# UNITED STATES PATENT AND TRADEMARK OFFICE

| APPLICATION NO. | FILING DATE | FIRST NAMED INVENTOR          | ATTORNEY DOCKET NO. | CONFIRMATION NO. |
|-----------------|-------------|-------------------------------|---------------------|------------------|
| 10/814,806      | 04/01/2004  | Javier Barandiaran Salaberria | BARANDIARAN2        | 5308             |

| <b>Office Action Summary</b> | <b>Application No.</b><br>10/814,806 | <b>Applicant(s)</b><br>SALABERRIA, JAVIER<br>BARANDIARAN |  |

## **DETAILED ACTION**

Appendix for Mitchell (4,133,345) unlabeled parts

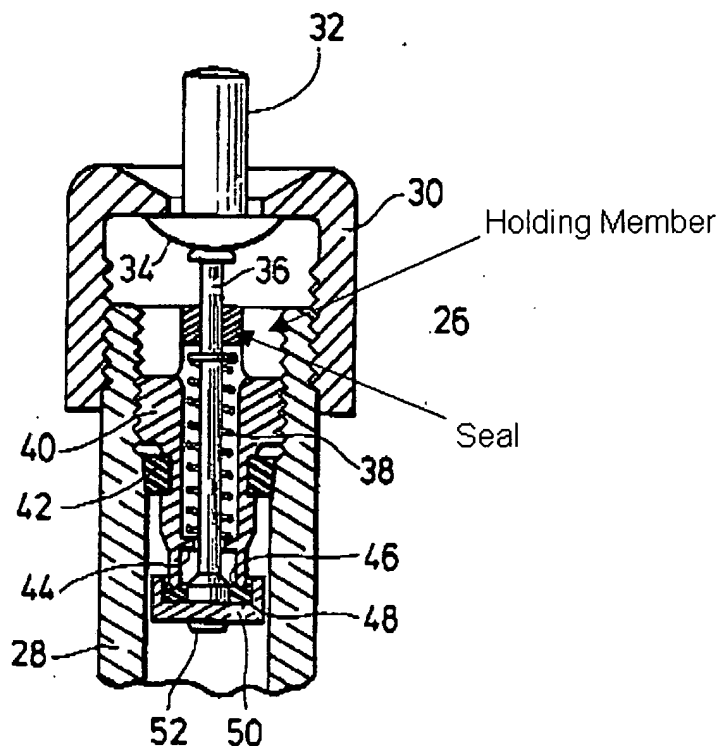
Regarding claim 1, Mitchell discloses a valve that has two concentric bodies (28, 30) with an intermediate chamber and a control rod (32) with a drive action area (top of actuating spindle 32) that resembles a semi-spherical surface with the force of actuation not limited to directions laterally and axially to the control rod.

In regards to claim 2, Mitchell discloses a valve device having three pieces (internal body portion 40, ring seal 42, and holding member (unlabeled, shown in attached Figure) that interact with sealing gaskets (closure member 48, and seal around the stem 36 (seal is unlabeled but shown in attached Figure)).
